# Application for a Planning Permit

Unit Number:	Street Number: <b>5</b>	Street Name: <b>Williamson Street</b>
Town: <b>Drouin</b>		Postcode: <b>3810</b>

Planning Application No:	PLA0117/24
Address:	5 Williamson Street DROUIN VIC 3818

SHEET NAME: TITLE SHEET		PROJECT: PROPOSED 2 RESIDENTIAL DEVELOPMENT		JOB NO. 10325		SCALE: NTS	DRAWN: mc	DATE: 24.11.2021	CHECKED: J MERIN	DATE: 24.11.2021	BY: TP00	REVISION: 2
----------------------------	--	--	--	------------------	--	---------------	--------------	---------------------	---------------------	---------------------	-------------	----------------

## EXISTING SITE CONDITION (SHEET TP01)

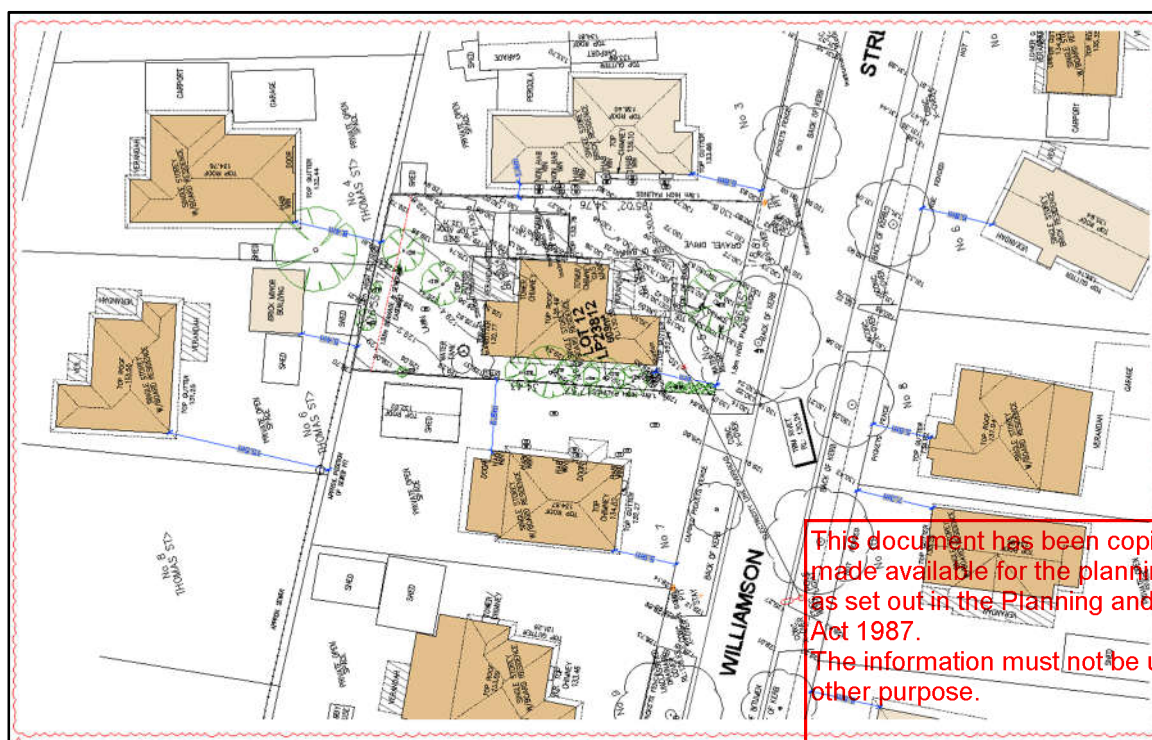
4. A Neighborhood and Site Description as required by Clause 55.01-1 of the Baw Baw Shire Planning Scheme. Further modify the plans to include the following details:

*Detailed survey of the site that measures and maps the elevations across the property has been provided. This survey includes contour lines, spot elevations, and benchmarks to show the relative heights. Please see image below together with the survey plan prepared by the licensed surveyor for reference.*

## PROPOSED SITE AND ROOF PLAN (TP02)

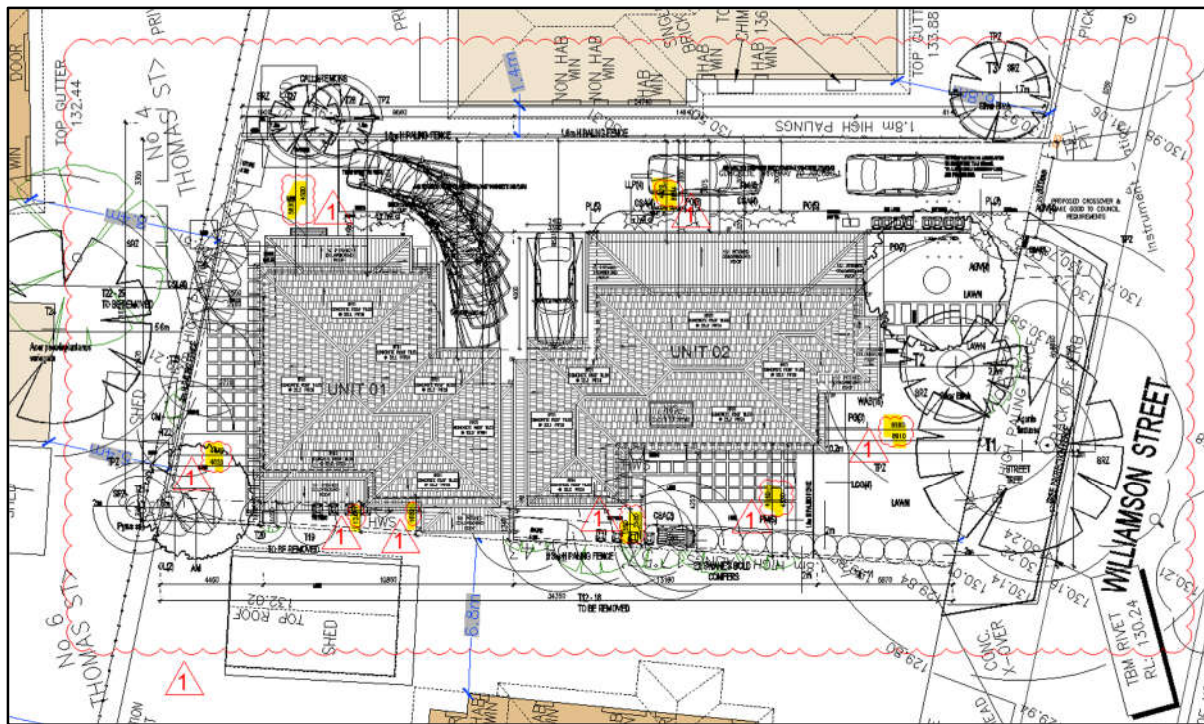
7. An amended set of fully dimensioned site development plans drawn to scale, clearly showing the following:

*Setbacks of buildings from driveway has been corrected and revised to comply the minimum 1.5 meters distance. Please see image below for reference.*

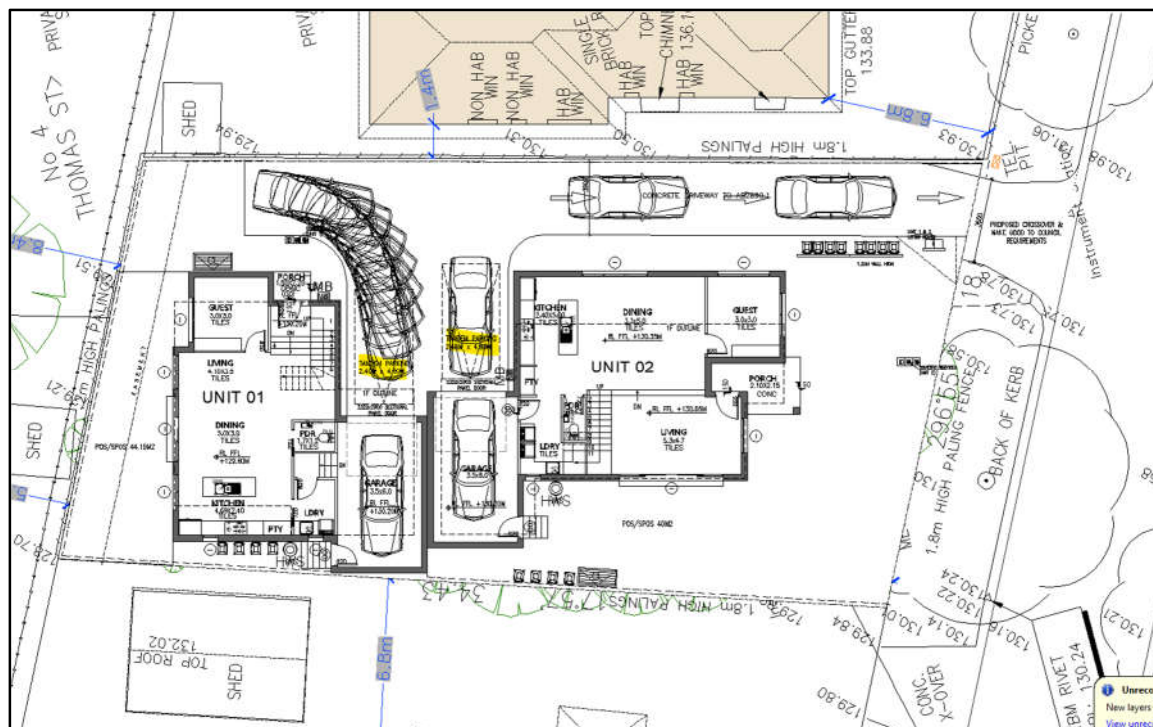
- i. Tandem carparking spaces to be more clearly defined, and dimensioned, a separate plan may be required.

*Separate plan with dimensioned Tandem parking has been provided. Please see image below for reference.*

## PROPOSED ELEVATION (TP05.2)

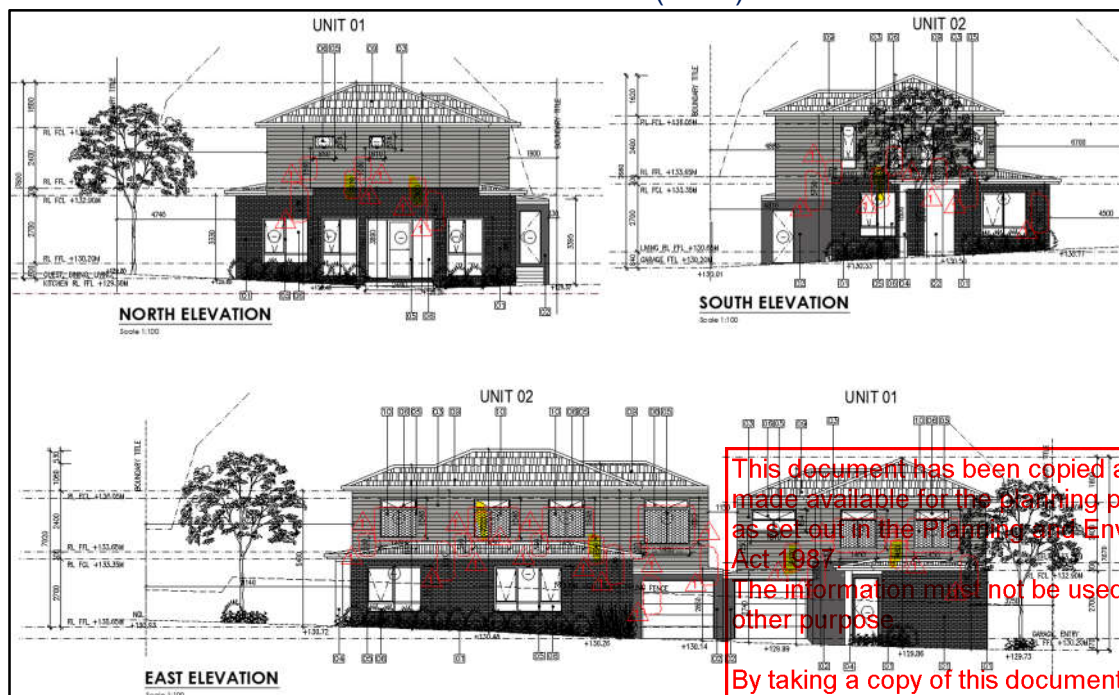
9. An amended set of fully dimensioned elevation plans drawn to scale, clearly showing the following:
  - a. Wall height from natural and finished ground level (for each building elevation).

### PROPOSED SITE PLAN (SHEET TP02)

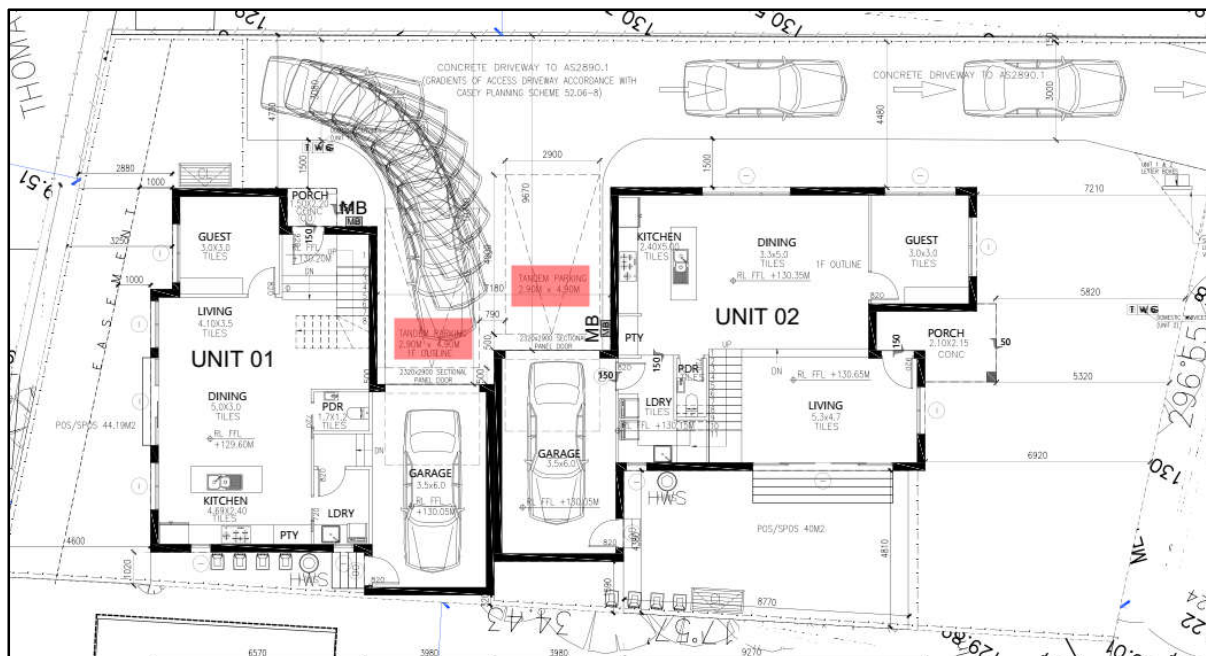
- g. Clearly show proposed bin collection area on the kerbside, council waste collection vehicles will not enter the property for collection from the 'Bin Area'

- Proposed bin collection area has been showed.*
